Customer Service Bulletin
Commercial Business Group

Greensmaster® 1000 \ 1600

Subject: Light Kit (04059) Rework.

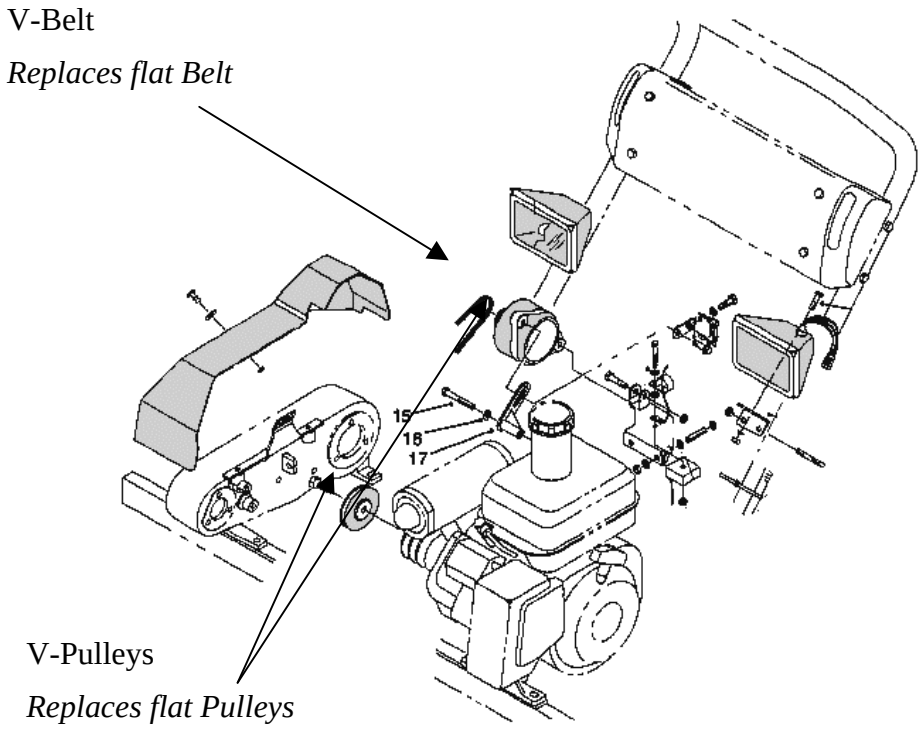
Light Kit (04059) was designed with a Flat Belt to drive the generator. If any misalignment between the Engine and Generator pulley exists, the belt can fail prematurely. All Light Kits (04059) will be reworked by your TORO distributor by installing Pulley Update Kit (98-5923). This kit will include a new 2L section V-belt and V-pulleys to replace the Flat Belt and Flat Pulleys. Contact your local TORO distributor to arrange for repairs.
